Product hierarchy no. *			Part no.	SBU	Type / Description	Customer part no.	
SBU	PG	PGU	Type				
01	001	025	0000000207	See list below	Circuit Protection	UST 1206	n/a

**2 Type of change**

UST 1206					0118.2312	
creation date	created by	release date	released by	notification no.	revision	page
2015-09-24	ruettiha	2015-12-04	ruettiha	-	-	1 of 2

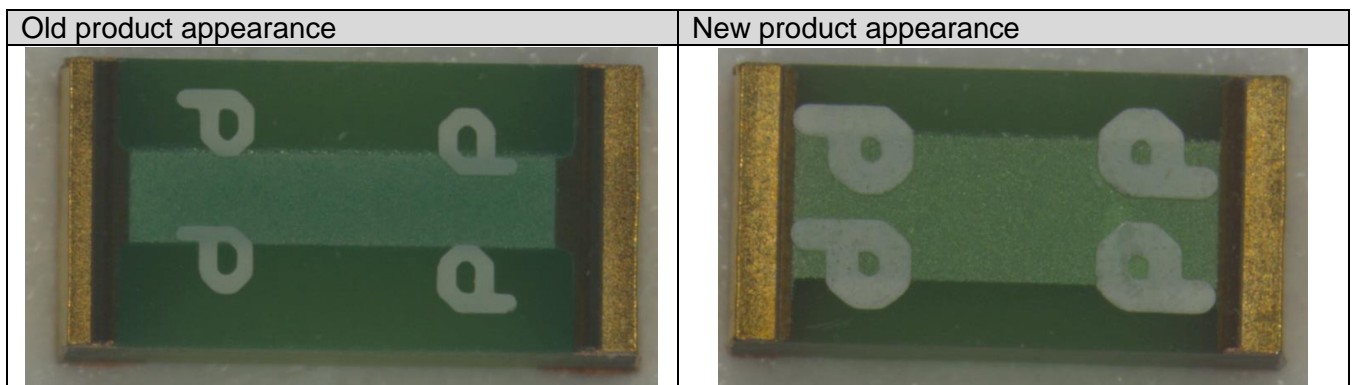
- Improved marking readability
- Adjusted layout of conductive path

Letters do not change

- Improve marking readability with a better contrast of the letter
- Improved layout of conductive path
